STAFF REPORT

ITEM: Boulder Ponds 5th Addition – Final Plat, Final PUD Plan Amendment

To: Ben Prchal, City Planner Re: Boulder Ponds 5th Addition – Final Plat

Cc: Ken Roberts, Planning Director Engineering Review Comments

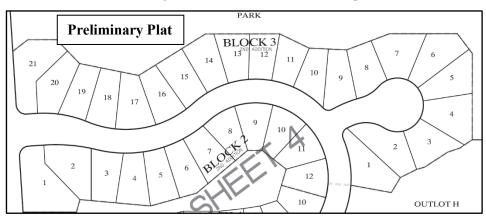
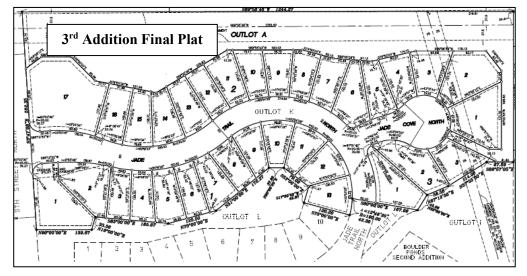
Changes to Final Plat from Preliminary Plat. Lot 17, Block 2 is much larger than originally approved with Preliminary Plat, (Lots 20 and 21 of the preliminary plat). The City Code requires amendment reviews to follow the process outlined in section 154.105. Although the intent of this section is to address zoning code and text amendments the process for

amending other land use requests, such as a PUD amendment can still apply. It can be seen that lot 17 from the 3rd addition is different from lots 20 and 21 from the preliminary plan. Lot 17 (Platted in 3rd addition) is the lot which the developer would now like to subdivide into 3 lots.

TITLE SHEET SITE PLAN

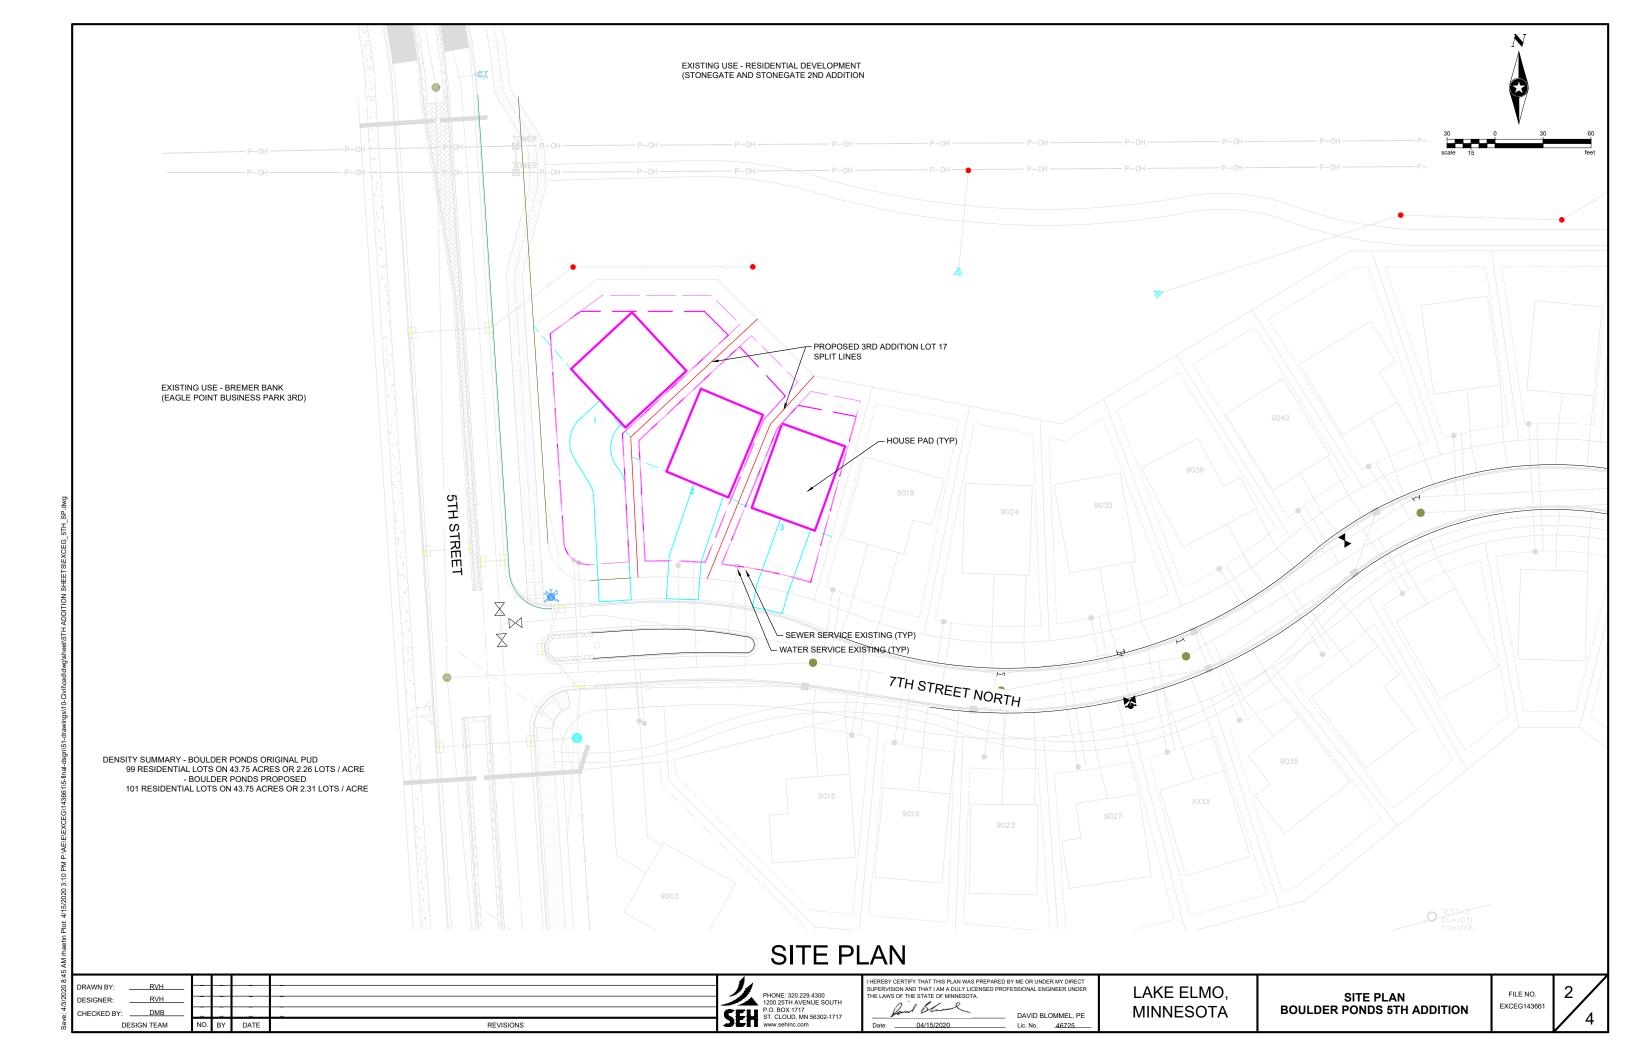
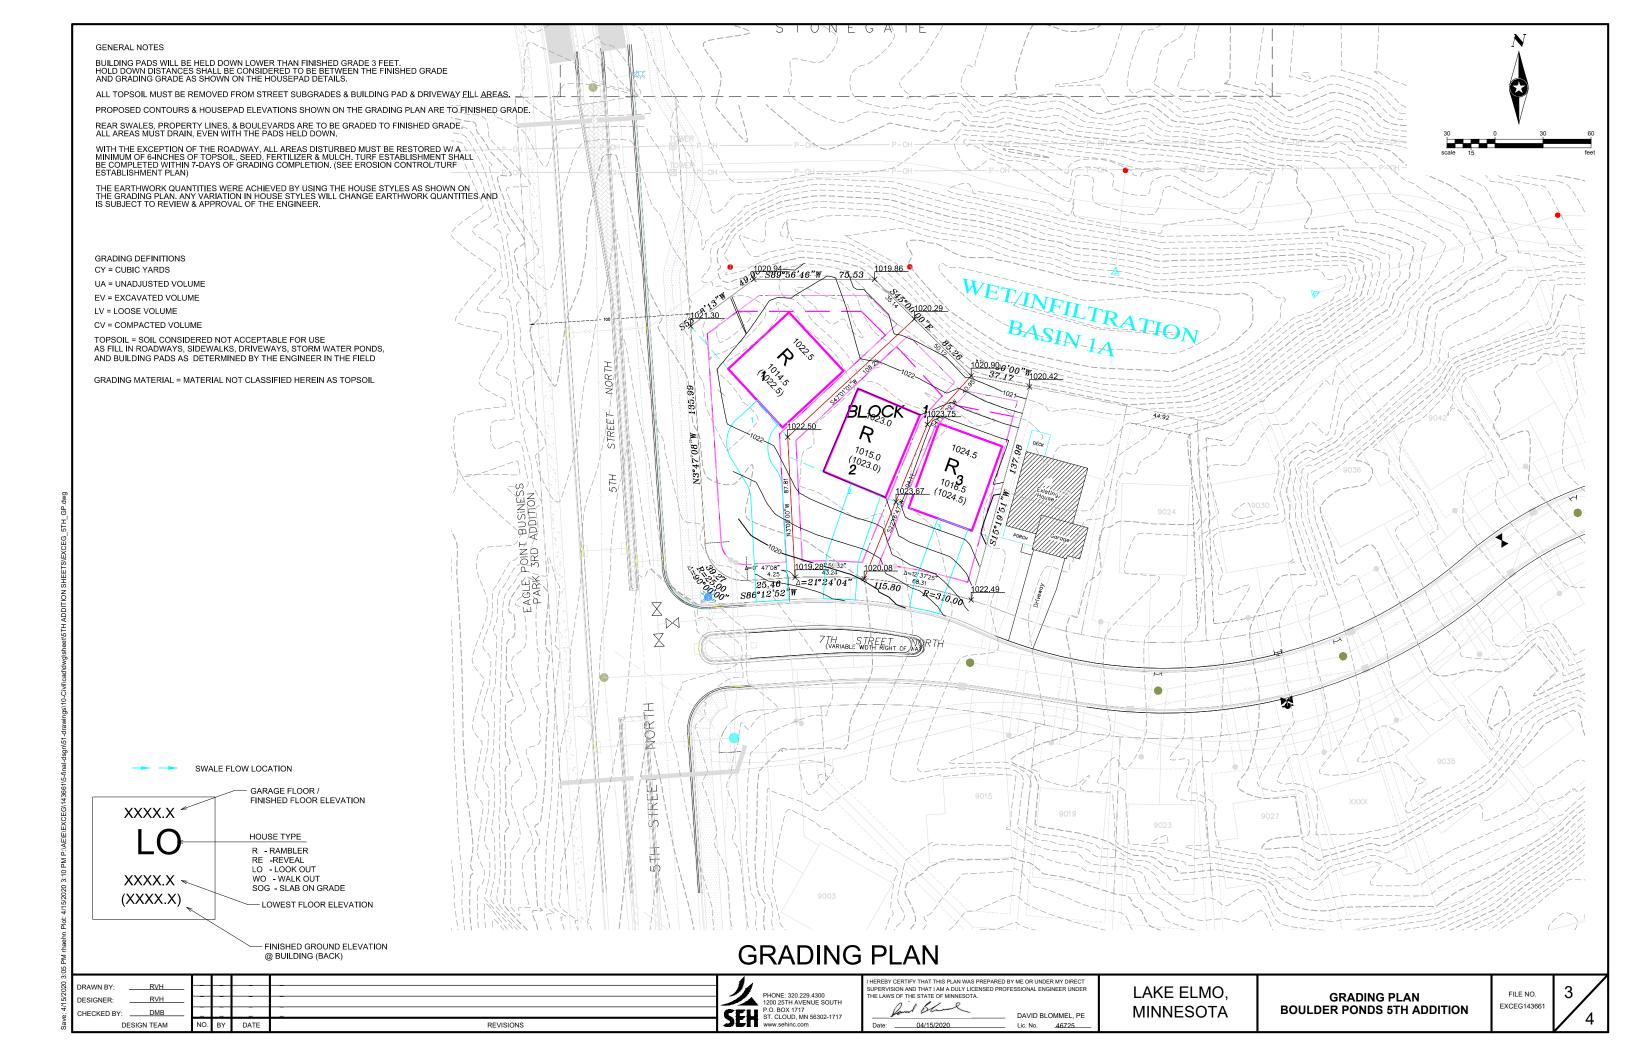
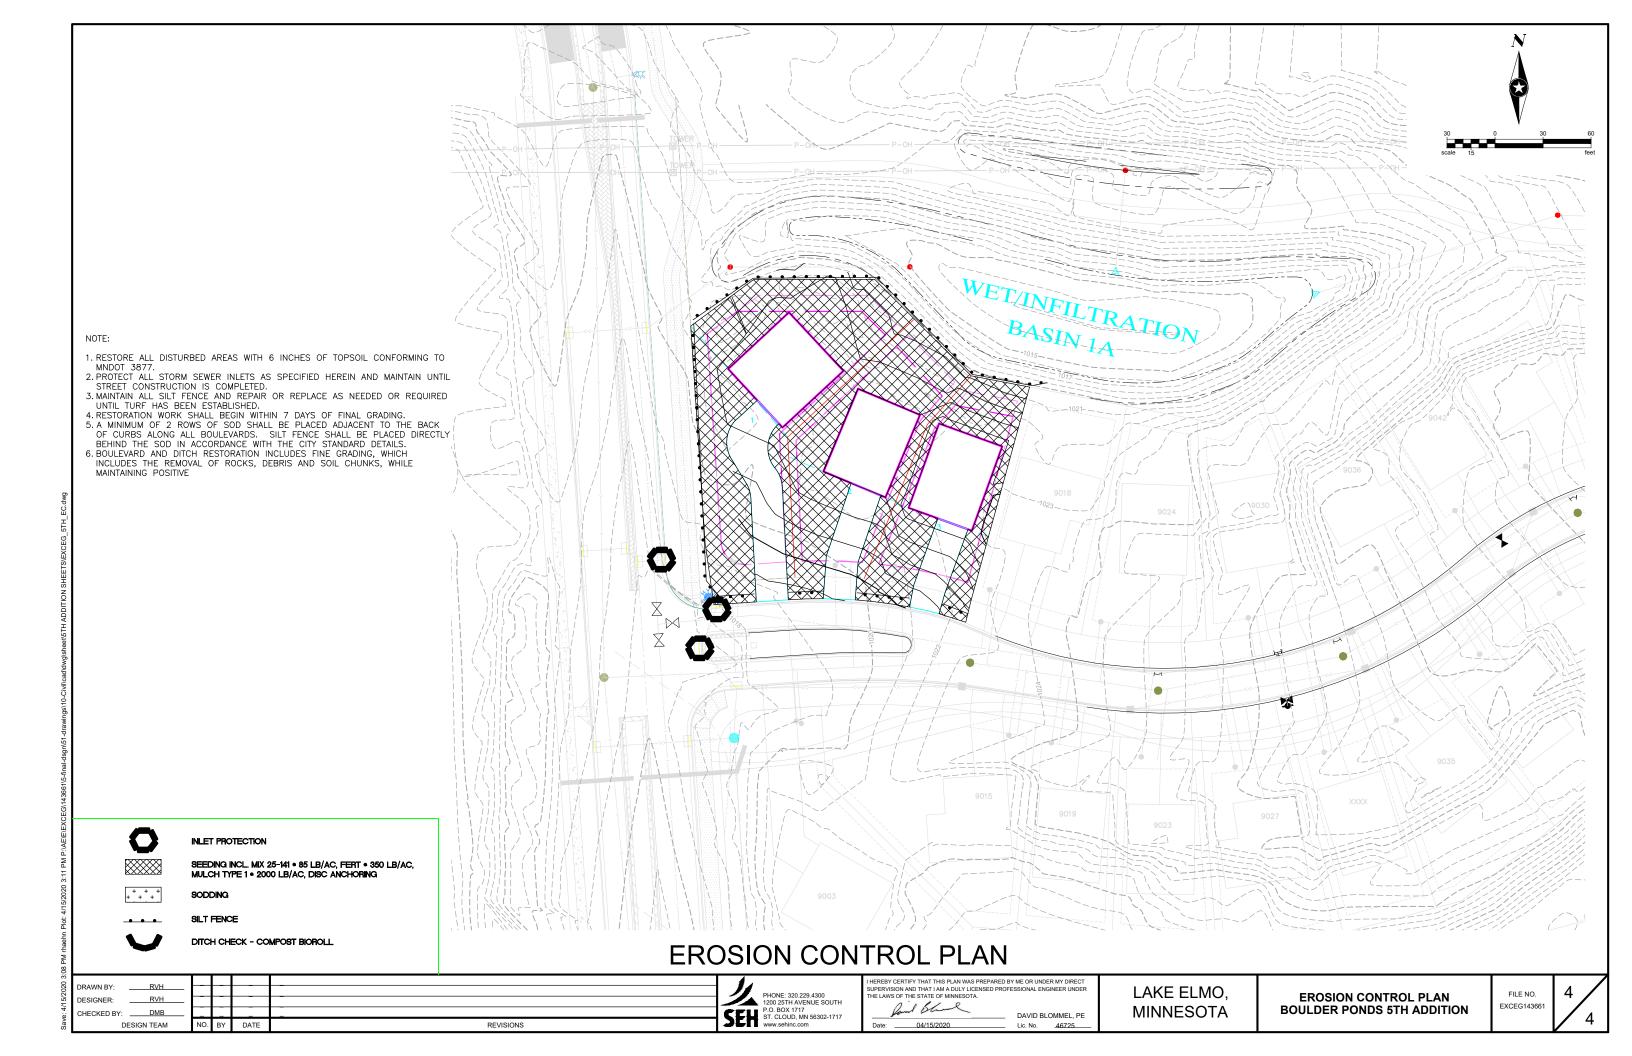
- It is recommended that the Final Plat be revised to plat only one additional lot instead of the proposed two lots. As proposed, Lot 1 Block 1 does not meet the minimum required lot width along 7th Street North, the primary road that requires the driveway access.

- The proposed lot width is not shown on the plans but appears to be a little over 40 feet in width. City ordinance in urban residential areas requires a minimum of 60 feet.

- The plans show the driveway layout for Lot 1 Block 1 and includes a "S" shaped alignment in order to connect the garage to the street curb cut. The city has experienced resistance by new property owners to construct their driveways in this type of configuration and have requested their builders to redesign the driveways after home construction. In this instance there is no alternative.

- 9. The Developer shall revise the plat to consist of one (1) additional lot as opposed to two (2) as requested. To clarify the 5th addition will consist of two (2) lots instead of three (3).
